**Proposal for Supplement 6 to the 03 series of amendments to  
UN Regulation No. 51 (Noise of M and N categories of  
vehicles)**

**Merge Document of GRBP/2019/13 from IWG ASEP with GRBP/70/06  
from OICA and GRBP/70/08 Rev.1 from ISO plus editorial changes  
during GRBP70.\***

The text reproduced below was prepared by the experts of IWG ASEP with the aim to provide clarification and corrections. The proposed amendments are based on UN Regulation No. 51, with all previous supplements incorporated. The modifications are marked in bold for new or strikethrough for deleted characters.

"Figure 3a

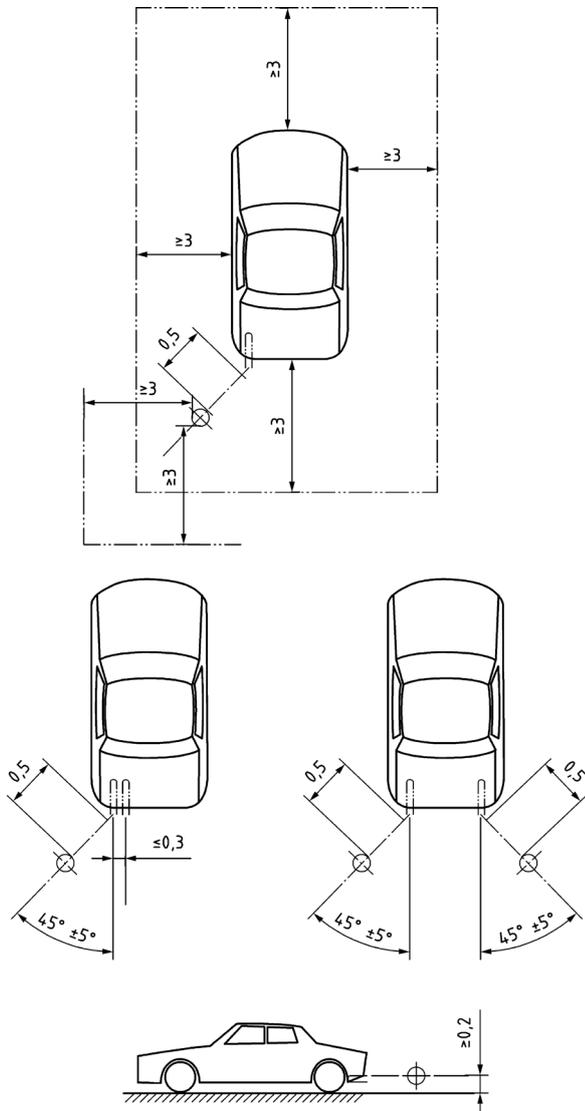
"3.2.5.3. Measuring of noise in proximity to the exhaust (see appendix of Annex 3, Figure 3a ~~2~~)"

8. The reference to the figure has been corrected.

Figure 3b

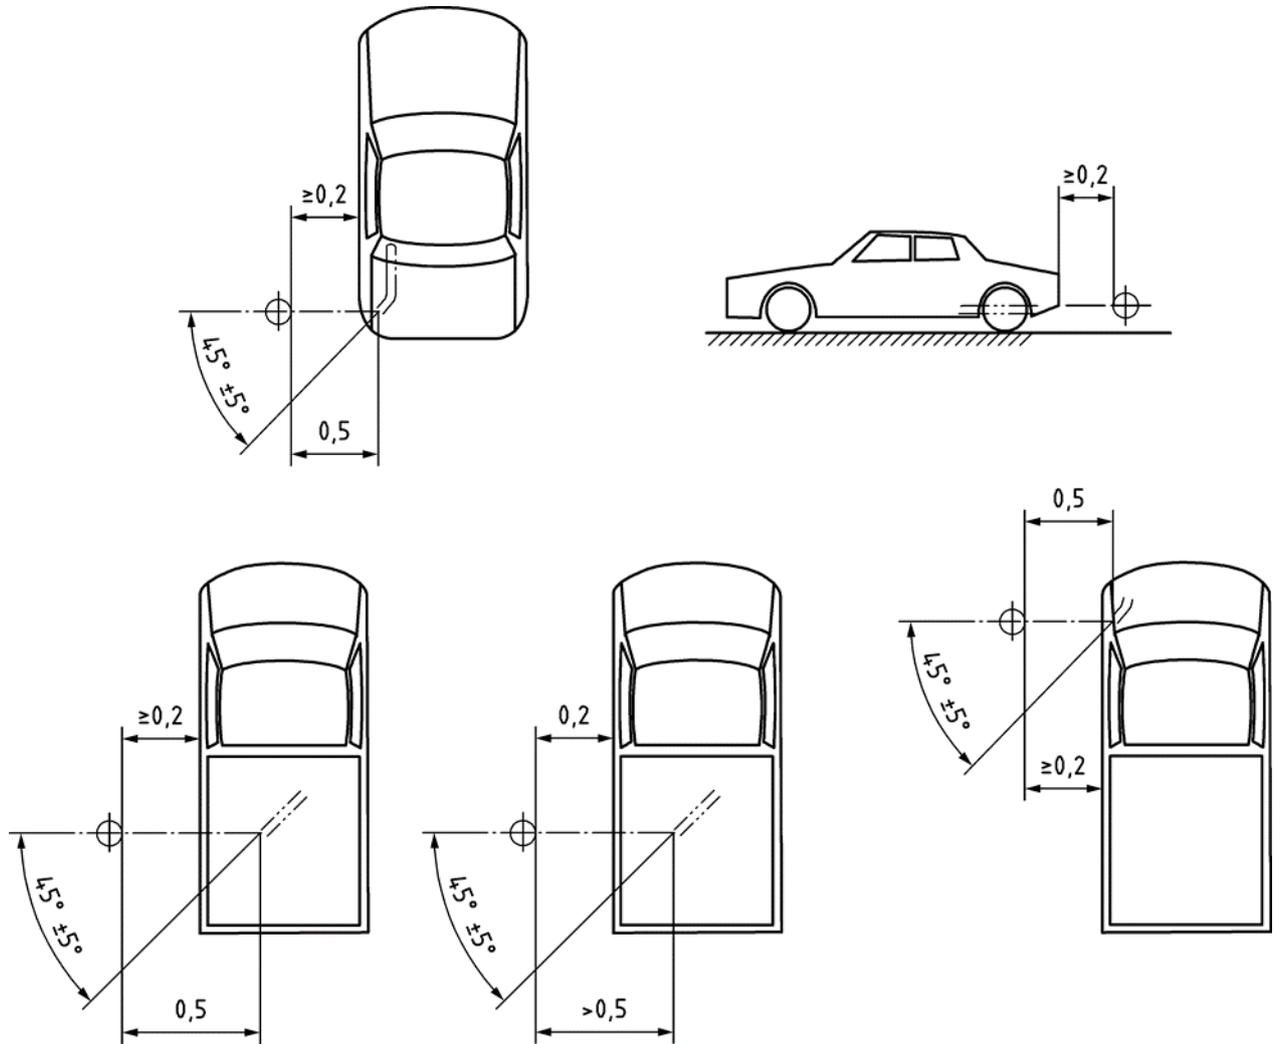
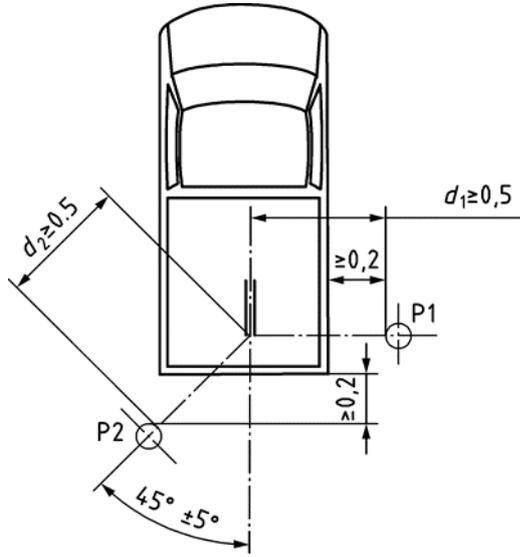
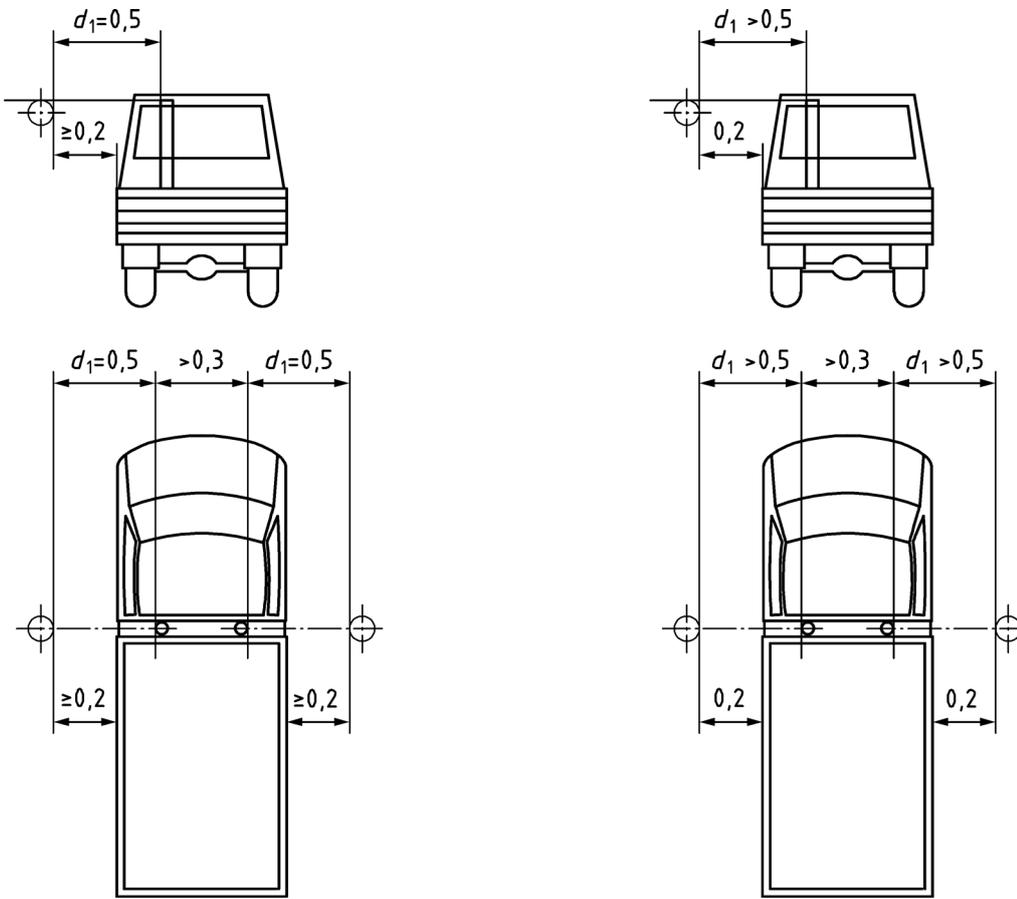
15. Figures 3b to 3d have been updated in according to the latest revision of ISO 5130:2019.12.

**For vehicles, where the reference point of the exhaust pipe is not accessible, or located under the vehicle body, as shown in Figure 3b and 3c in Annex 3, because of the presence of obstacles which form part of the vehicle (e.g. spare wheel, fuel tank, battery compartment), the microphone shall be located at least 0.2 m from the nearest obstacle, including the vehicle body, and shall not be located under the vehicle. Its axis of maximum sensitivity shall face the exhaust outlet from the position least concealed by the above mentioned obstacles. In case the distance from the exhaust outlet to the other side of the vehicle is larger than 0.2 m (Figures 3c and 3d in Annex 3), the following distances of  $d_1$  and  $d_2$  shall be chosen:**

**Case 1:**

**$d_1$  shall be equal to 0.5 m and the distance from the side (outer border of the vehicle) shall be at least 0.2 m.**

**$d_2$  shall be equal to 0.5 m and the distance from the side (outer border of the vehicle) shall be at least 0.2 m.**

**Case 2 (if Case 1 is not fulfilled):**

**$d_1$  shall be at least 0.5 m and the distance from the side (outer border of the vehicle) shall be equal to 0.2 m.**

**$d_2$  shall be at least 0.5 m and the distance from the side (outer border of the vehicle) shall be equal to 0.2 m.**

**When several positions are possible, as shown in Figure 3c, the microphone position giving the lowest value of  $d_1$  or  $d_2$  shall be used."**

"Figure 4a

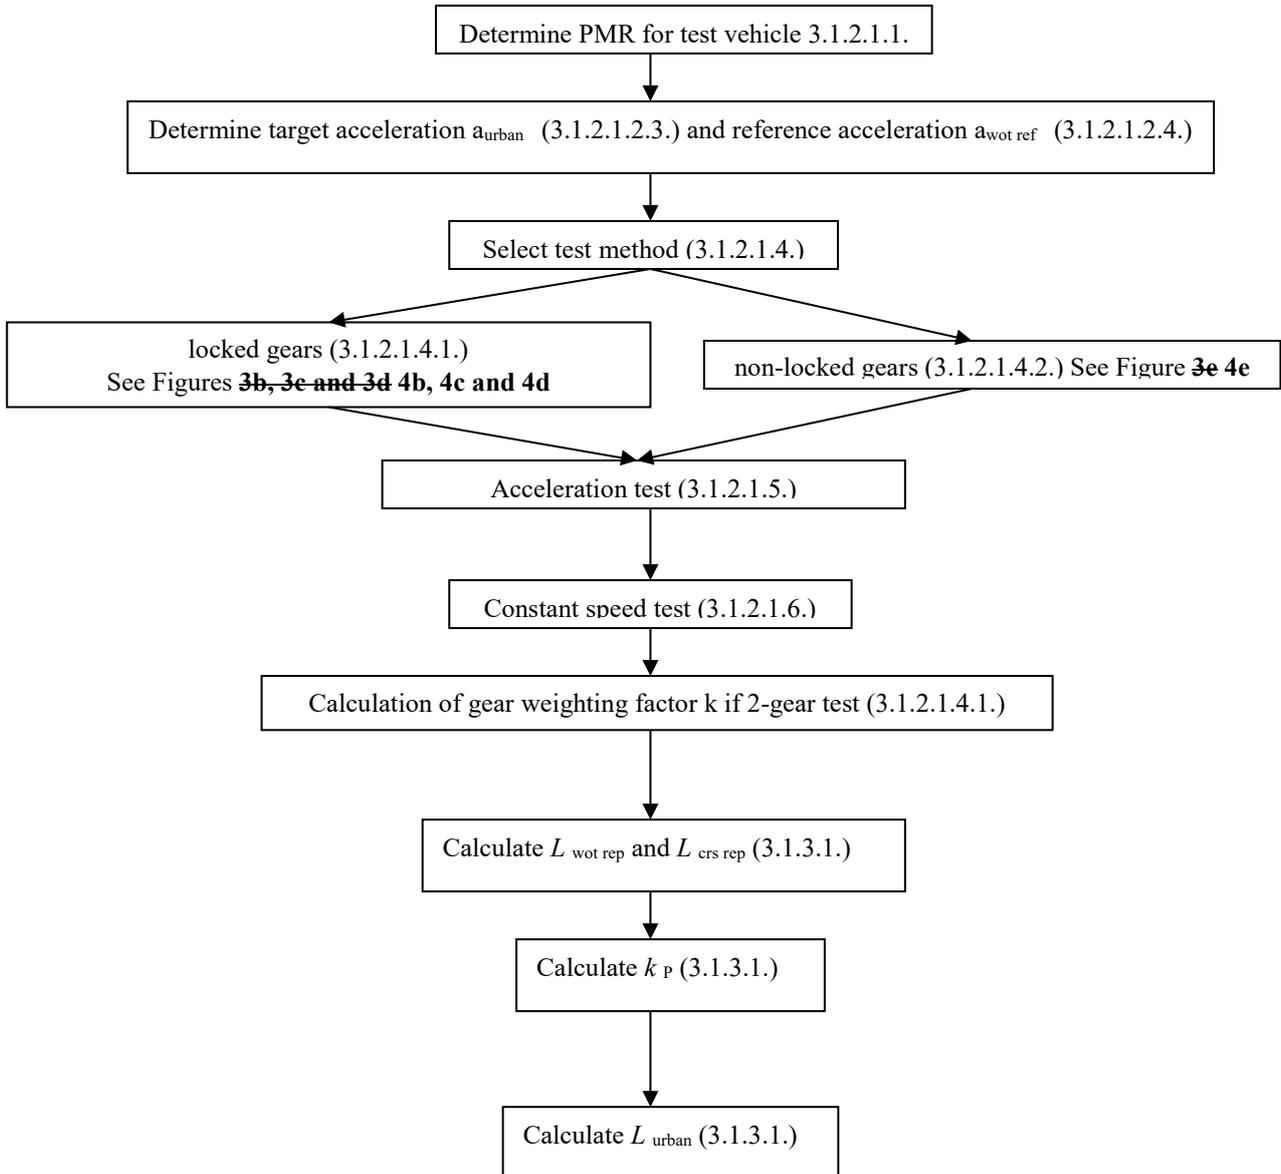
16. The following modifications have been made: for Figure 4a - correction of references; for Figure 4b - reference for stable acceleration was added; for Figure 6 - the flowchart for stationary sound was added for more clarity.

Flowchart for vehicles tested according to paragraph 3.1.2.1. of Annex 3 to this Regulation  
– ~~L<sub>urban</sub>~~-L<sub>urban</sub> computation

"Figure 4b

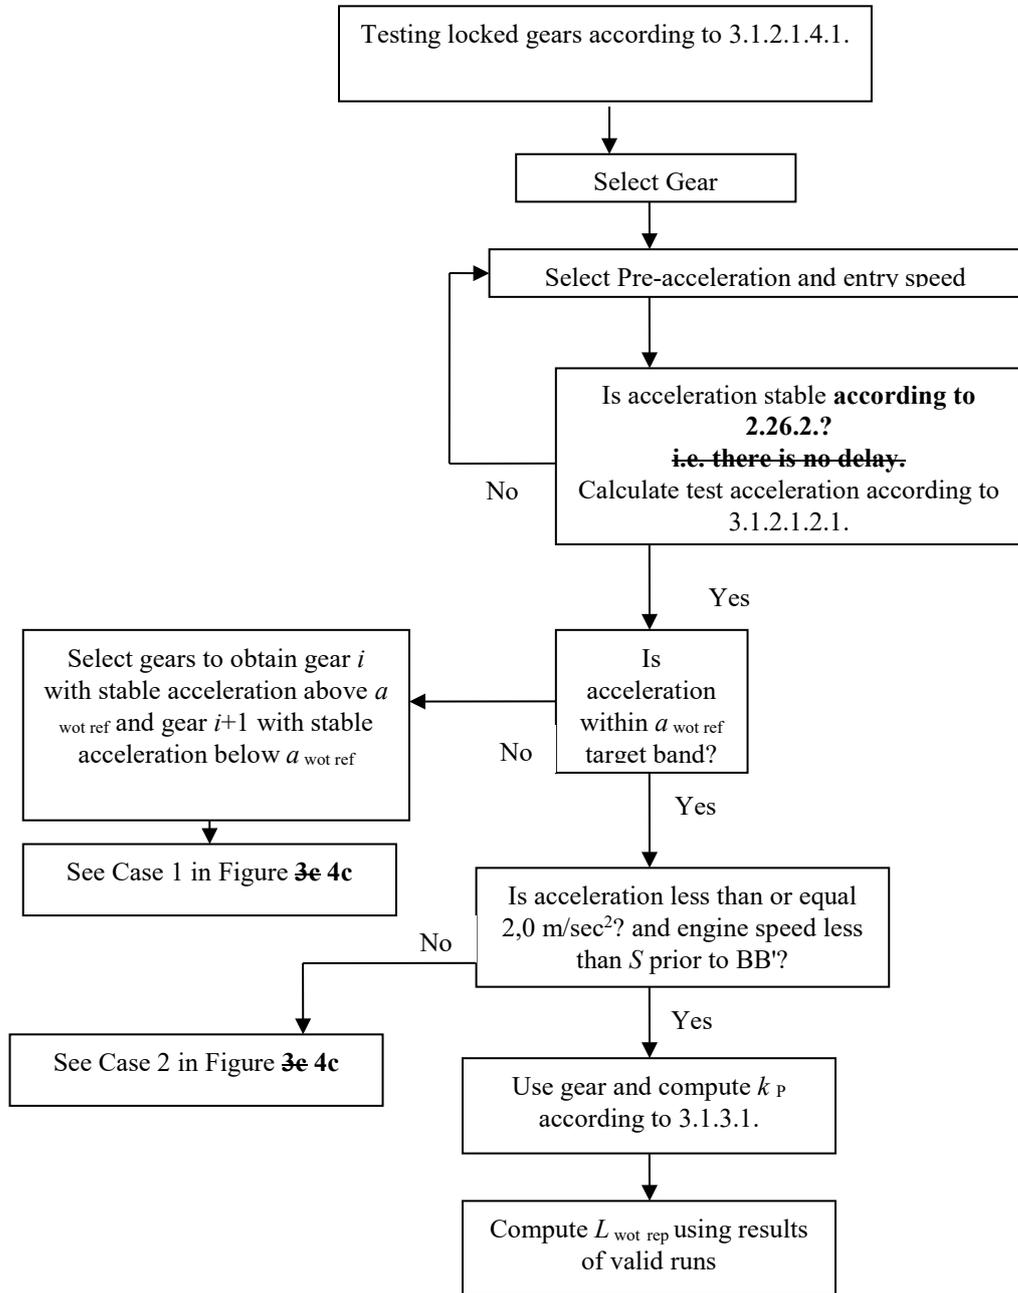
*Annex 3, paragraph 3.1.2.2., paragraph 3.1.2.2.1.1. and Appendix, Flowchart 4b*

7. Clarification was added according to the new definitions for stable acceleration

Flowchart for vehicles tested according to paragraph 3.1.2.1. of Annex 3 to this Regulation  
 - Gear selection using locked gear. PART 1
